# TOYOTA TECHNICAL SERVICE BULLETIN

REF.: BODY  
NO.: BO94-007  
DATE: MAY 20, 1994  
MODEL: RN/VN

## WINDSHIELD WIND NOISE REPAIR

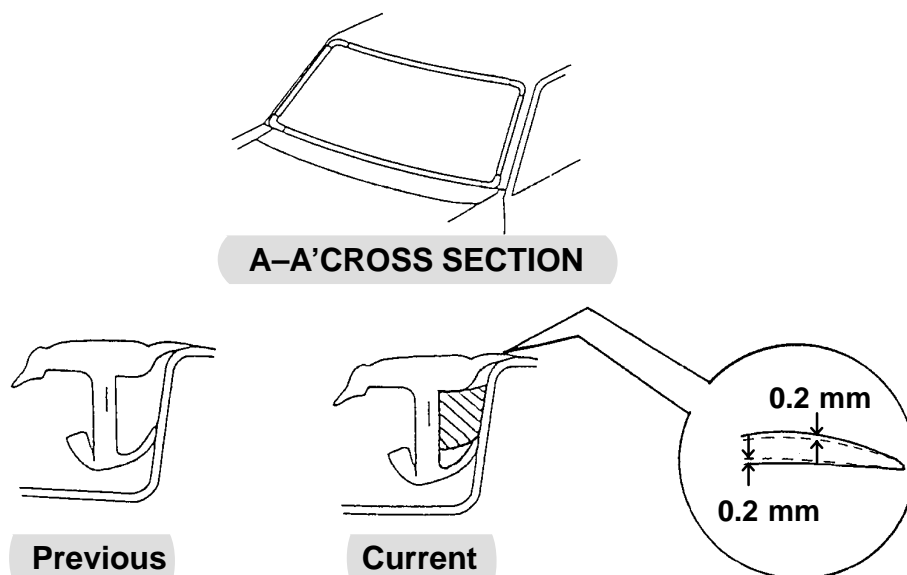
To reduce wind noise around the upper windshield area, air dam sponges have been added between the body and molding (at ends of upper windshield molding). Additionally, the rigidity of the windshield molding lip has been increased.

### ADDITION OF AIR DAM SPONGES

### INCREASED WINDSHIELD MOLDING RIGIDITY
